**JOINT REGIONAL PLANNING PANEL**  
**(Sydney East Region)**  
**SUPPLEMENTARY REPORT**

JRPP No	2015SYE151
DA Number	13/200/12
Local Government Area	City of Botany Bay
Proposed Development	Section 96(2) Application to modify Development Consent No. 13/200 to change selected residential units within buildings in Quadrant 2 and Quadrant 4 to re-categorise the multi purpose rooms to bedrooms, changing the unit mix of the development from 62% to 54% studio/1 bedroom apartments and to recalculate car parking rates under the amended SEPP65, changes to car parking allocation to reduce residential parking and create a retail surplus.
Street Address	19-33 Kent Road, Mascot
Applicant/Owner	Karimbla Construction Services (NSW) Pty Ltd
Number of Submissions	Nil
Regional Development Criteria (Schedule 4A of the Act)	Section 96(2) Application to modify a consent for an application previously determined by the JRPP.
List of All Relevant s79C(1)(a) Matters	<ul style="list-style-type: none"> <li>• List all of the relevant environmental planning instruments: s79C(1)(a)(i) <ul style="list-style-type: none"> <li>○ State Environmental Planning Policy No. 65 – Design Quality of Residential Apartment De

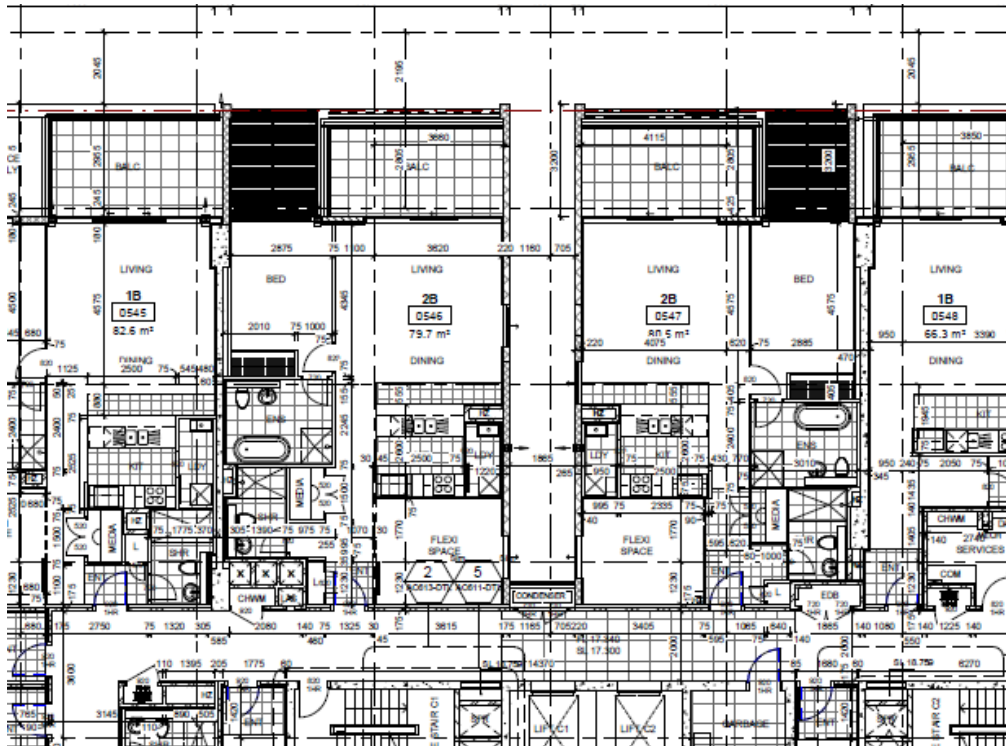
As detailed at the discussion meeting held on 31 March 2016, a total of 25 apartments are examples of bedroom windows in close proximity to another habitable window of an adjacent apartment. These are discussed below, however it has been confirmed by the Applicant and Council's Accredited Certifier that in fact in each case, the bedrooms will comply with the BCA. The windows represent 10% for the floor area of each room and the windows remain accessible to the open sky. Each window can be physically opened as required by the standards, to provide cross ventilation.

Notwithstanding this, the applicant was requested to consider physical changes to improve visual and aural amenity between the corresponding windows, and Meriton has advised that this will be problematic as the apartments are already constructed. The applicant has confirmed that they have reviewed the subject apartment layouts and advise that there is no objection to a condition requiring the windows be treated with permanent obscure glazing.

This form of treatment is considered the most appropriate option. Some of these rooms will look out onto other multi purpose rooms, which are not proposed to change to bedrooms. In this instance, it is reasonable to expect that blinds or curtains will also be installed. The applicant has agreed to obscure glazing. In order to maintain amenity to the bedrooms, natural ventilation will be required. Therefore, the windows should be fixed translucent to 1500mm with clear operable windows above 1500mm.

*Prior to the issue of the relevant Occupation Certificate, the windows in the rooms changing from multi purpose rooms to bedrooms are to be fixed translucent to 1500mm with clear operable windows above 1500mm. (DA13/200/012)*

## Building E

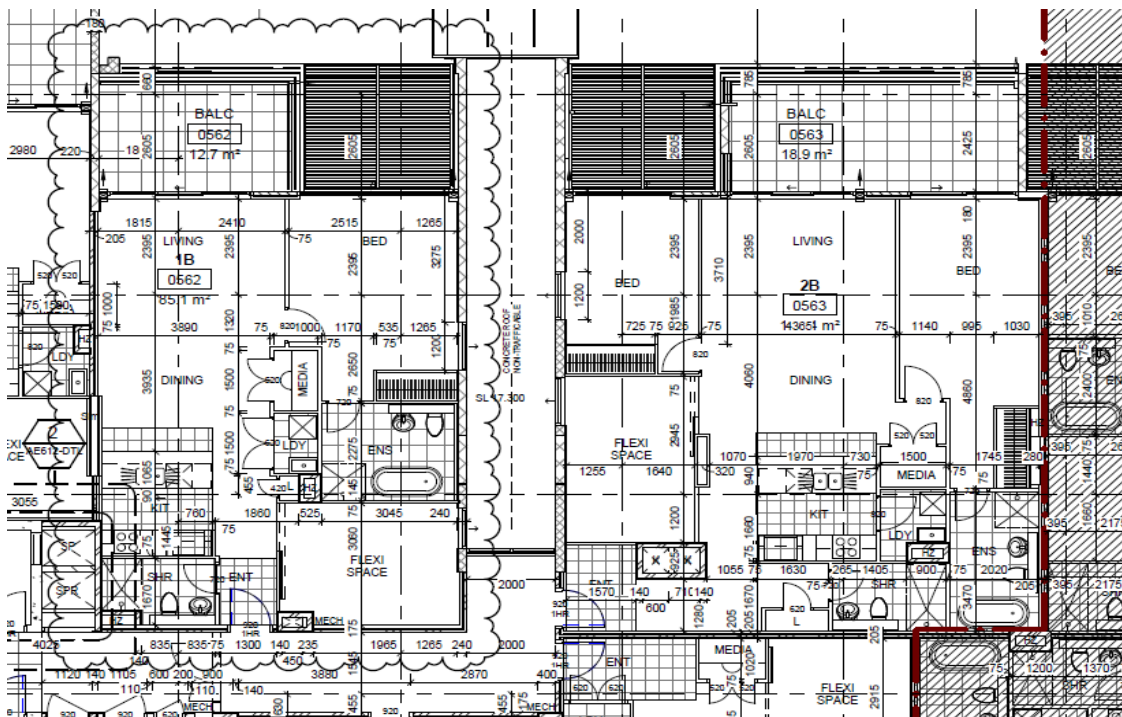
In building E, only three (3) apartments are of concern, where the snorkel bedroom windows will be slightly offset. In this regard, it is still recommended that permanent obscure glazing be provided to the window of the room which is changing, in accordance with the draft condition.

## Building H

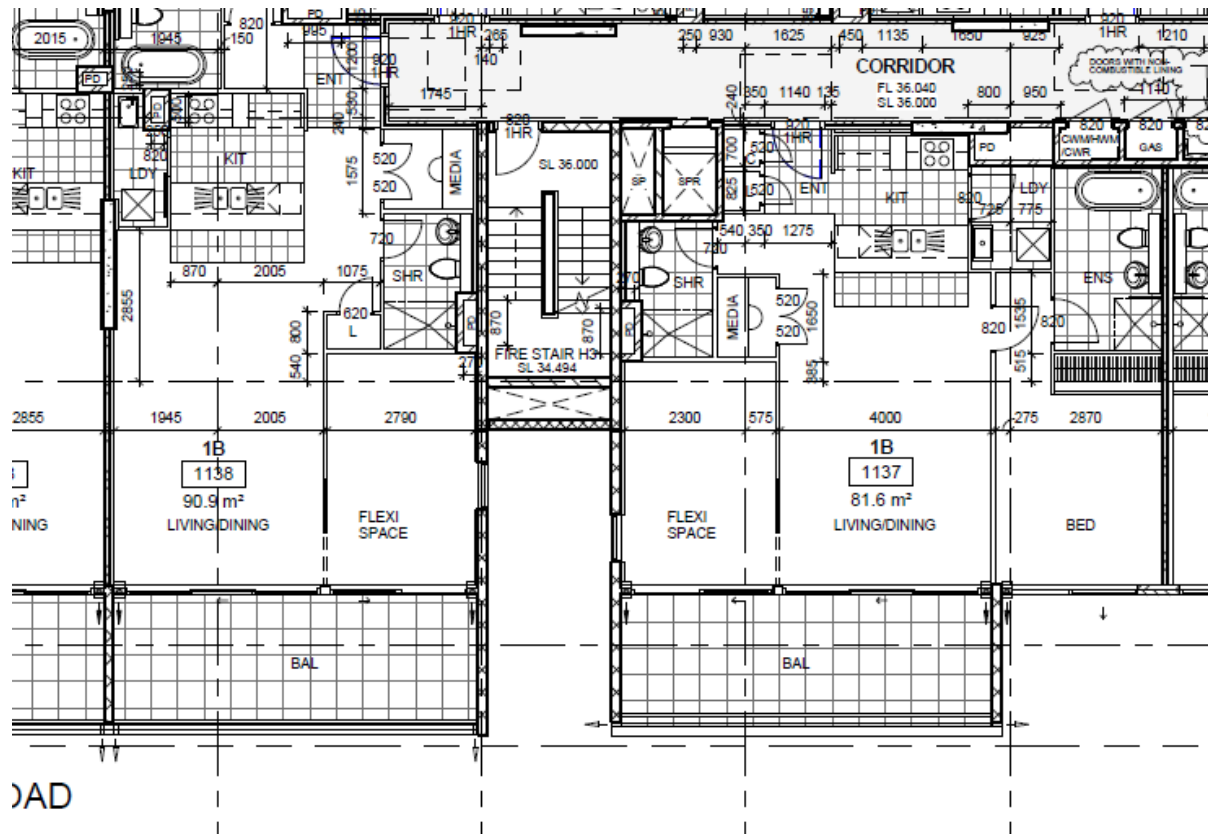
17 apartments are of concern, however in each case a second window or balcony opening is provided and or the corresponding apartment is not proposed to change its multi purpose room to a bedroom, therefore, only one of the corresponding windows requires to be treated with permanent obscure glazing, in accordance with the draft condition.
